STATE OF NEBRASKA
DEPARTMENT OF ROADS
ADDENDUM NO. 1
PROJECT NO. ENH-30(13)
CONTROL NO. 42479/002
CALL NO. 450
GENEVA WARNER FILLING STATION
TOURISM CENTER
LETTING DATE: JUNE 16, 2011

3. BUILDING SECTION

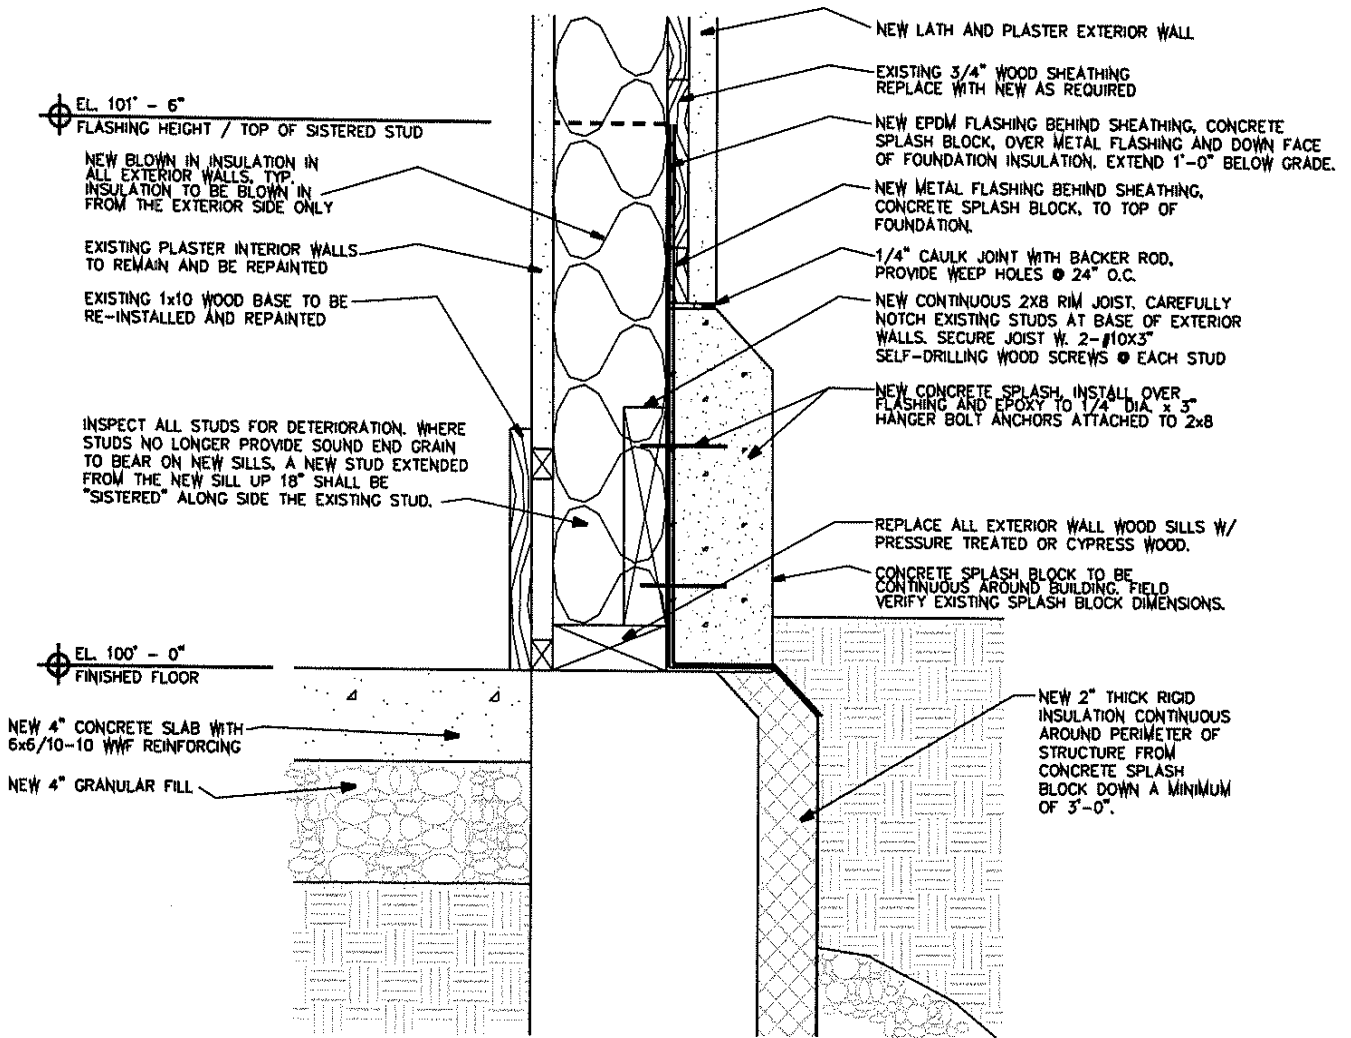
On plan sheet 8 (A-300), detail “3 - Building Section” is void and superseded by the new detail “3 – Building Section” as depicted on the attached sheet.
